MONTGOMERY COUNTY HISTORIC PRESERVATION COMMISSION STAFF REPORT

Address: 35 Oxford Street St., Chevy Chase Meeting Date: 1/6/2021

Permit No.: 936673 **Staff:** Dan Bruechert

Proposal: Accessory building demolition, accessory building construction, and building alterations.

Figure 2: 1927 Sanborn map showing the subject property and accessory structure.

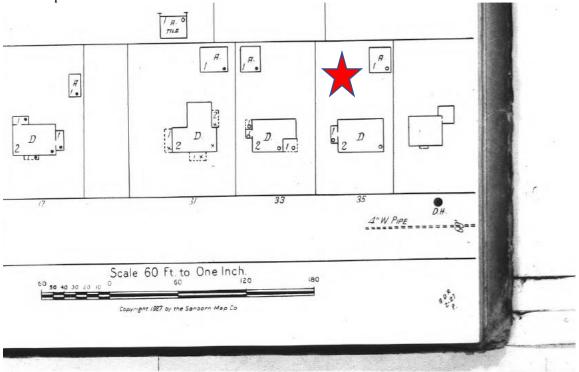
of single lite casement windows. Staff has not examined the interior of the structure to be able to determine if the existing accessory structure is the same one shown in the 1927 Sanborn map (below) or is a later replacement.

While Staff does not take a position on the construction date of the existing accessory structure, the *Design Guidelines* require alteration of detached accessory structures to be reviewed under lenient scrutiny. Staff finds the alterations to the building have resulted in a loss of material and design integrity of the structure. An additional factor Staff considered is the function of the building. At some point, the applicant (or a previous owner) truncated the driveway at the rear wall plane and relocated the HVAC units so the rear of the lot is no longer accessible to vehicles. Staff finds that the demolition of the structure will not impact the surrounding streetscape and supports demolition of this structure under the *Design Guidelines* and chapter 24A-8(b)(2) and (d).

EXISTING GARAGE PLAN

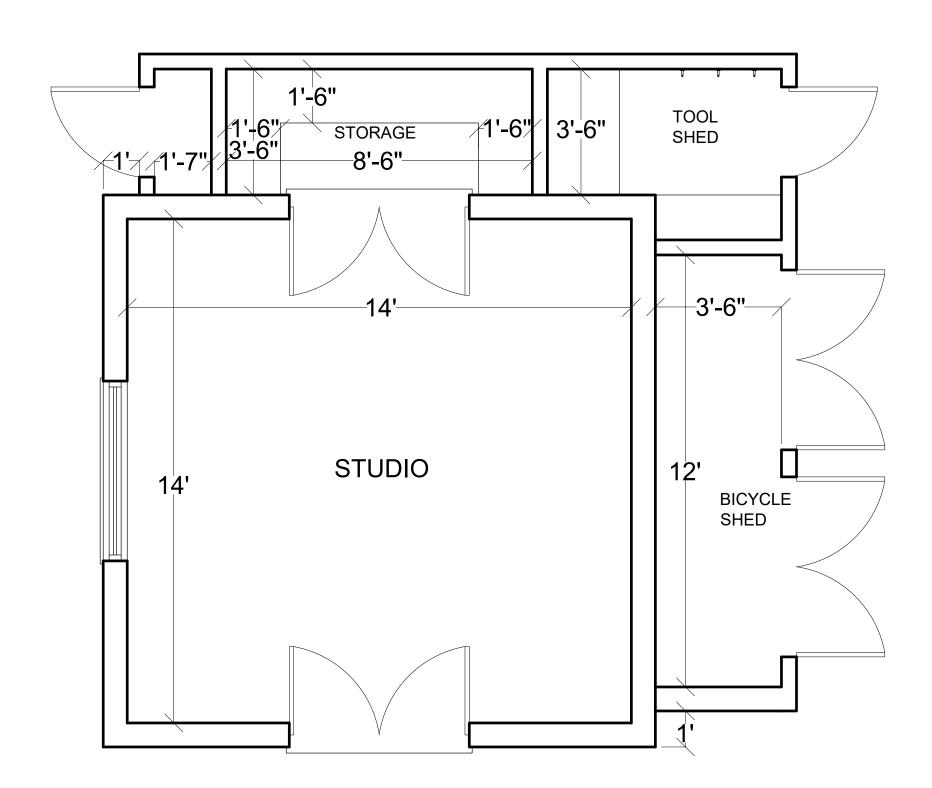
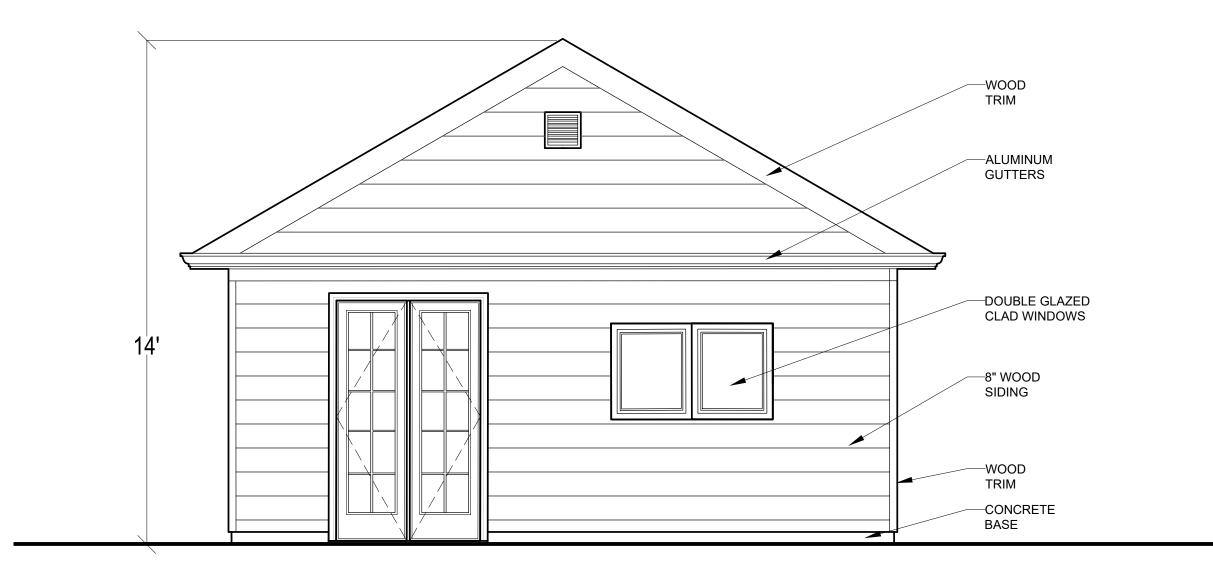
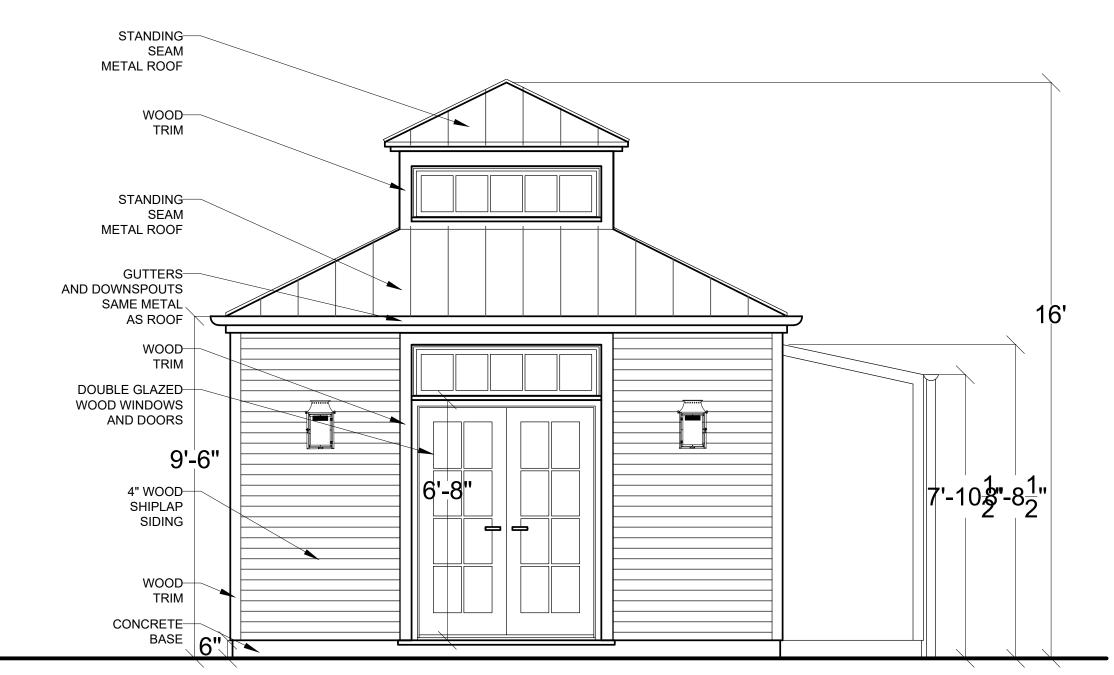
In the northeast corner of the lot, there is an accessory structure. The structure has a front-facing gable and is in the form of a garage, measuring 17' 2" (seventeen feet, two inches) square; though there are no garage doors. In place of a garage door, the street-facing elevation has a pair of French doors and a pair

In the location of the existing accessory structure, the applicant proposes to construct a new structure described as a "pavilion/shed" in the application materials. The proposed structure is approximately the same size, only 3" (three inches) longer and wider than the existing structure. The principal difference in the form of the accessory structure has a pyramidal roof with a cupola, which makes the height of the proposed building one foot taller than the existing one. The exterior of the new structure will be covered in wood shiplap siding in a 4" (four-inch) reveal. The roof will be standing seam metal with wood trim at the cupola. The south elevation has a pair of wood French doors with a multi-lite transom. The west elevation has a large 20-lite picture window with a transom. The east elevation has several doors that access additional storage and the north elevation has a blank wood elevation. The building is constructed at the minimum setback requirements in the northeast corner of the lot.

Under the *Design Guidelines*, a detached garage or accessory structure is to be reviewed under lenient scrutiny, but need to be compatible with the main building. Staff finds that in considering the size, scale, and compatibility with the streetscape, the proposed building satisfies the requirements under lenient scrutiny. The size of the proposed structure is approximately the same as the existing building, which

will not overwhelm or detract from the house. Staff finds that, while the cupola is an architectural embellishment, because the building is so far removed from the street it will not impact the surrounding streetscape. Finally, Staff finds that the wood-sided accessory building is compatible with the existing construction in its simple form and materials. It will not visually compete with the historic building and Staff finds an appropriate infill under 24A-8(b)(2) and (d) Standards 9 and 10, and the *Design Guidelines*.

A202

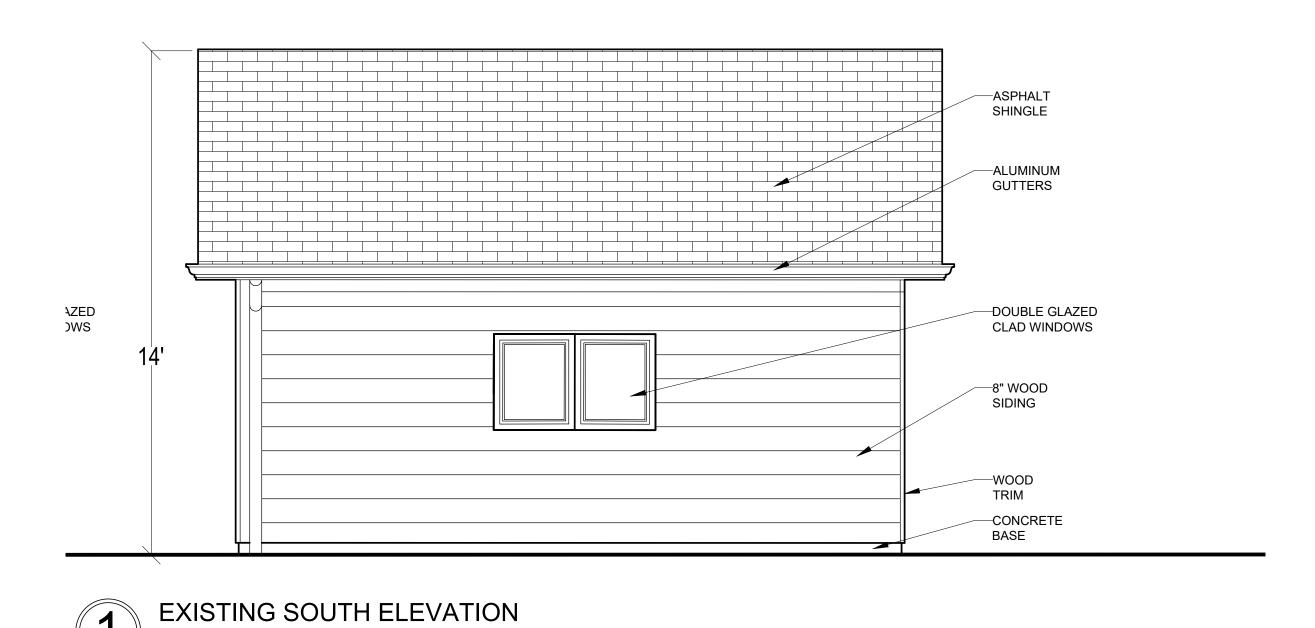
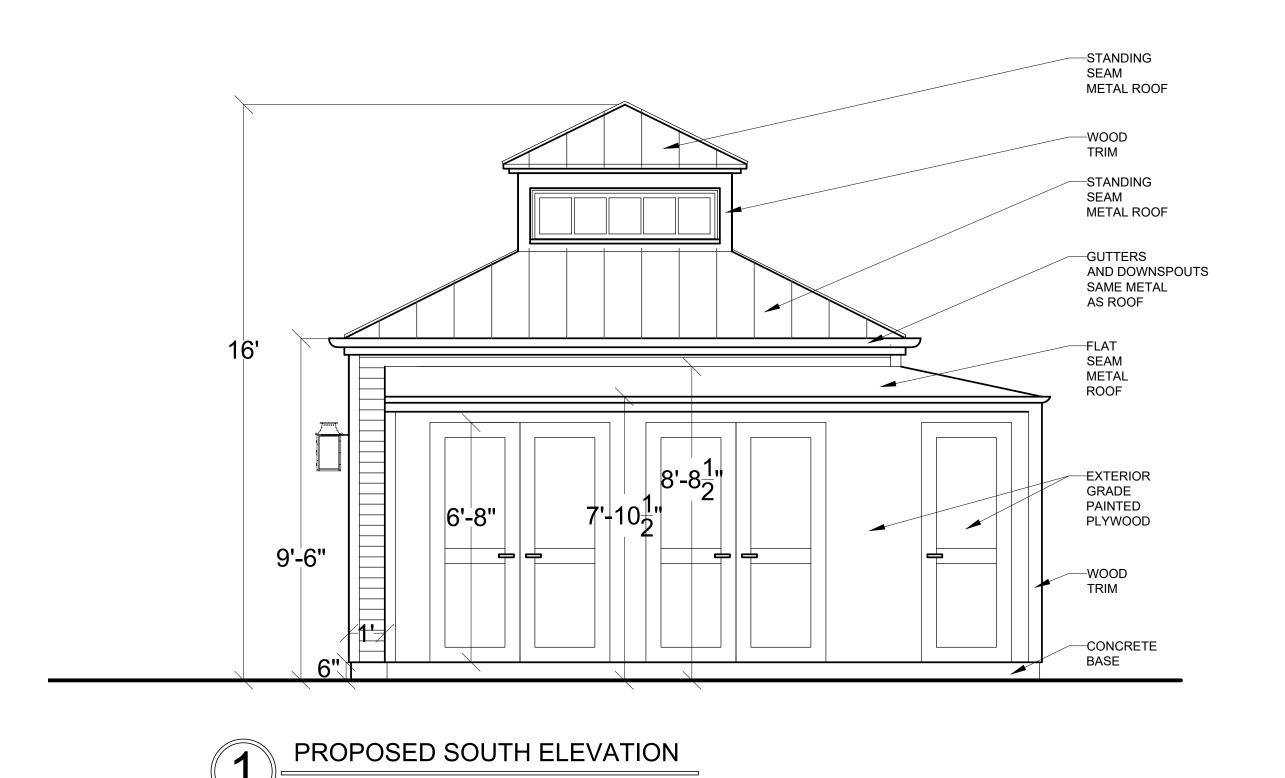
Above the front entrance and above the one-story, non-historic right-side addition the applicant proposes constructing a wooden railing, approximately 30" (thirty inches) tall. Staff found a listing for a similarly detailed handrail called a "Geometric X Chippendale" railing or a "Southern Cross" detail. Staff also found an example of this railing on a Neoclassical house (circa 1936) in "A Field Guide to American Houses." While the *Design Guidelines* do not have a category for railings, decks, porches, and fences are all to be reviewed under moderate scrutiny if visible from the public right-of-way. Staff finds these are appropriate analogs and recommends evaluating this proposed feature under that standard. Staff finds that the design and material are appropriate for a feature of this era. Additionally, Staff finds the size of the railing will not detract from the character of the house. Staff also finds that this feature could easily be removed in the future without damaging the integrity of the site (per Standard 10). Staff recommends the HPC approve the new railing under 24A-8(b)(2) and (d), the *Design Guidelines*, and Standard 10.
